## PSE state machine related issues (Comment r02-137, 145.2.7 P 144 L 33)

## New comment (not submitted. Clause 145.3.3.3.5 Page 191 line 48)

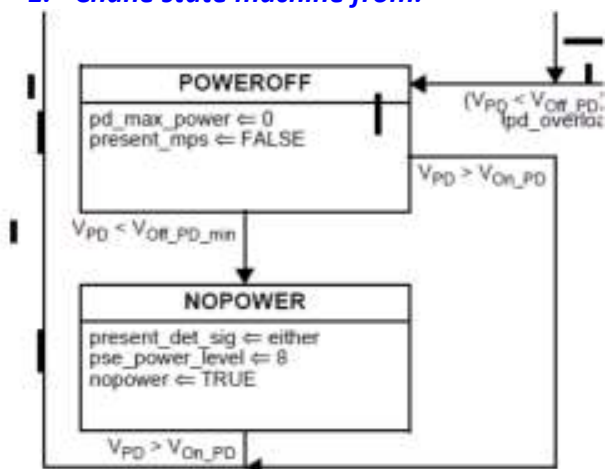
- PD requested class is 8 and the assigned class is 6.
- When transitioning from NOPWER back to POWERED, the PSE has still available power of 6 (that is why it has assigned class to 6) and now power level is 8.

The  $pse\_power\_level=8$  will cause the  $pse\_assign\_class$  in POWER\_DELAY to be:

$pse\_assign\_class = \min(pse\_power\_level, pd\_req\_class) = \min(8, 8) = 8$ .

This in turn will set  $pd\_max\_power$  in POWERED to be:

$pd\_max\_power \leftarrow \min(pse\_assigned\_class, pd\_req\_class) = \min(8, 8) = 8$  which is  $>$   $pse\_available\ power = 6 \rightarrow$  PSE OVERLOAD condition.

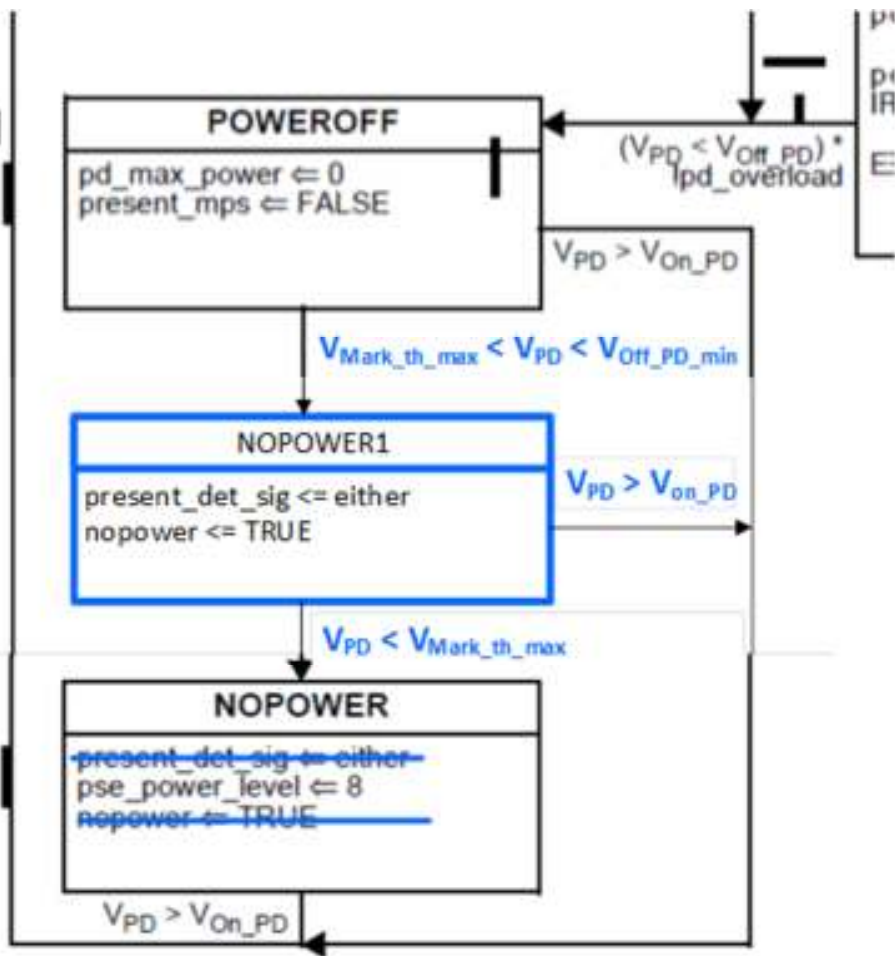
In the PD state machine in NOPOWER we have the assignment  $pse\_power\_level \leftarrow 8$  that may cause overload condition in the PSE whenever the assigned power is lower than the required power.

The overload condition happens when we force compliant PDs in NOPWER that do remember their assigned class (and their  $pse\_power\_level$ ) data to redefine their  $pse\_power\_level$  in NOPOWER to higher power level in NOPOWER when PSE has no knowledge about it.

The assignment  $pse\_power\_level \leftarrow 8$  in NOPOWER looks redundant at least if the PD remembers its  $pse\_power\_level$  when PD input voltage is above  $VReset\_PD\_max$  (2.81V), or  $VReset\_th\_max$  (6.9V) which ensures sufficient voltage to PD to keep its memory.

Asking PD to assign  $pse\_power\_level \leftarrow 8$  in NOPOWER for  $V_{PD} < V_{Off\_PD\_min}$  without specifying that the lowest value for  $V_{PD} < V_{Off\_PD\_min}$  is  $VReset\_th\_max$  is the issue.

This comment tries to minimize the exposure of a compliant PD that do remember its  $pse\_power\_level$  to be forced to reassign  $pse\_power\_level$  to 8 which will cause that PD to cause PSE overload which is uncompliant behavior after that PD that didn't go to IDLE was behave in a compliant way.

The proposed remedy is based on reducing the input voltage range in which we are forced to assign  $pse\_power\_level$  to 8 from:  $V_{pd} < V_{Off\_PD\_min}$  to:  $V_{mark\_th\_max} < V_{pd} < V_{Off\_PD\_min}$ .

#### 1. Chane state machine from:

To:

2. Repeat the proposed changes for dual-signature PD.
